PREPARED FOR THE PLAN COMMISSION

Project Address: 710 East Mifflin Street and 124 North Livingston Street
Application Type: Demolition and Rezoning
Legistar File ID # [32794](#) and [32797](#)
Prepared By: Heather Stouder, AICP, Planning Division
Report Includes Comments from other City Agencies, as noted

Existing Zoning of Subject Site

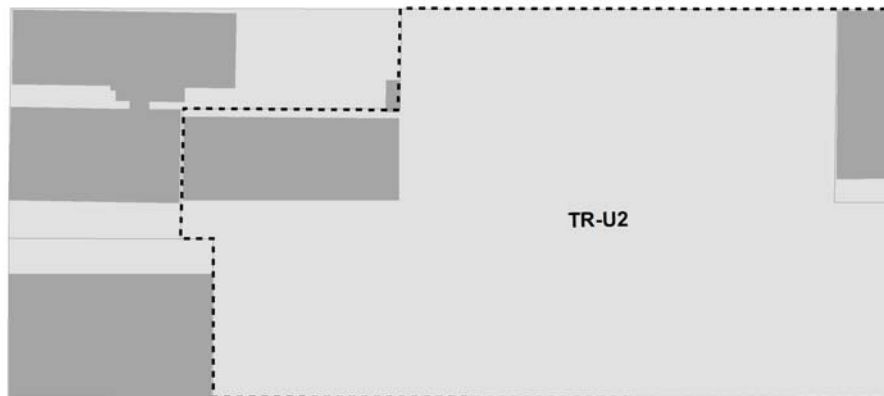
However, due to a nuance in the zoning code, staff recommends that for the time being, the zoning immediately surrounding the existing brick building on the property remain PD, and that the remainder of the property be rezoned to TR-U2. As has been noted, staff understands that conversion of the existing building to residential use could not occur in an early phase of the project, and that it will likely continue to be utilized for storage for the foreseeable future. If the entire property were to be rezoned to TR-U2 at this time, the use of the building would become a legal non-conforming use, which is not inherently problematic. The issue is that zoning requirements would prohibit the construction of a new multi-family residential building on the same property with a non-conforming use. Thus, as long as the non-conforming use was to continue in the TR-U2 District, no residential development could occur on the site.

As a solution, staff recommends that the area surrounding the existing building remain in the PD District as it is today, with a zoning text specifically allowing for the current use to continue, and that the remainder of the property be rezoned to TR-U2 at this time. If this applicant or a future property owner wishes to pursue conversion of the existing building for residential or other uses, a rezoning of the property surrounding the building could be requested again at that time, providing a better opportunity for review of the relationship between the existing building and any new development on the site. Staff understands that the applicant and the existing tenant in the building are both supportive of this solution (see illustrations on following page, with subject property outlined in dashed line).

1. The applicant shall work with Planning and Zoning staff to amend the existing Planned Development District Zoning for 710 East Mifflin Street so that it encompasses the existing two-story brick building on the property, and limits allowable uses to the current storage use.
